Office Action Summary

09/802858

Onda et al.

Claims 1-3, 5-9, 11-14 and 16-20 are rejected under 35 U.S.C. 102(b) as anticipated by or, in the alternative, under 35 U.S.C. 103(a) as obvious over Onda (JP 9-309319).

The modification is illustrated below:

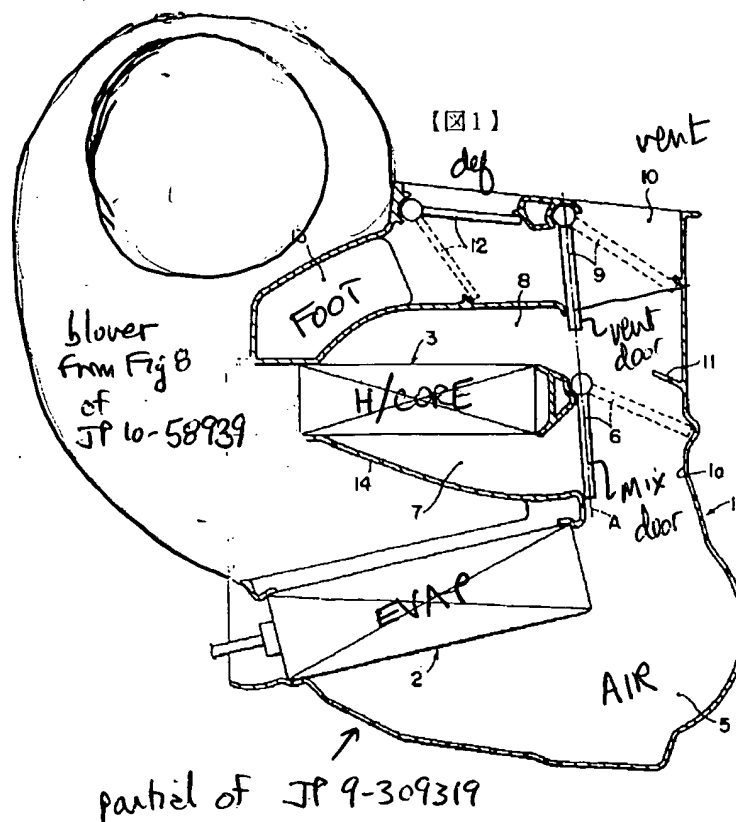
Claims 1-3, 5-9, 11 – 14 and 16-20 are rejected under 35 U.S.C. 103(a) as being unpatentable over the combined teachings of Onda (JP 9-309319) and Taihichi (JP 10-58939).

Onda in Figures 1 and 5 shows the claimed subject matter with the exception of a down-flow blower.

JP 10-58939 teaches a downflow blower in Figure 8. To have used the down-flow blower of JP '939 in Onda to advantageously avoid a side mounted blower to "miniaturize" (see Abstract of JP '939) the resulting structure would have been obvious to one of ordinary skill in the art.

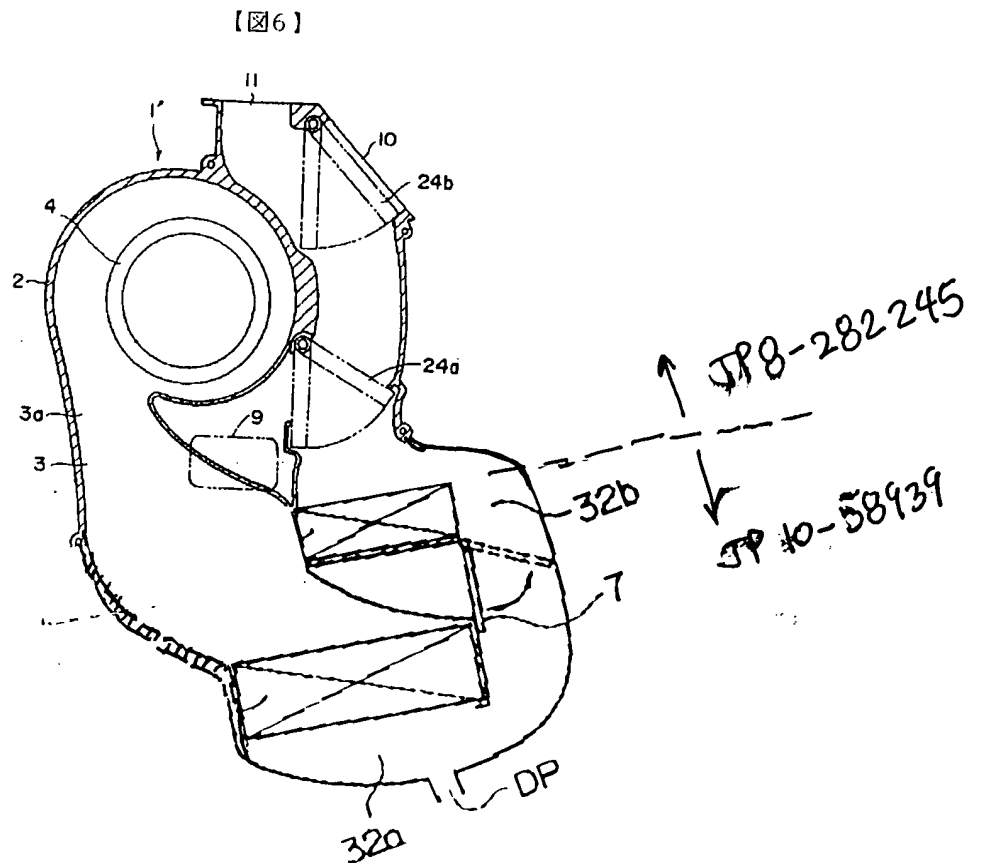
Claims 1-3, 5-9, 11-14 and 16-20 are rejected under 35 U.S.C. 103(a) as being unpatentable over the combined teachings of JP 10-58939 and JP 8-282245.

Figures 8-12 of JP '939 bear a striking resemblance to what is disclosed in this application, with the exception that the foot outlet is formed on the front part of the casing rather than closer to the blower.

JP'245 teaches forming the foot discharge 9 at the position claimed by applicants.

To have combined the respective teachings of JP '939 and JP'245 to obtain the structure shown on the next page would have been obvious to one of ordinary skill in the art to obtain a more compact structure.
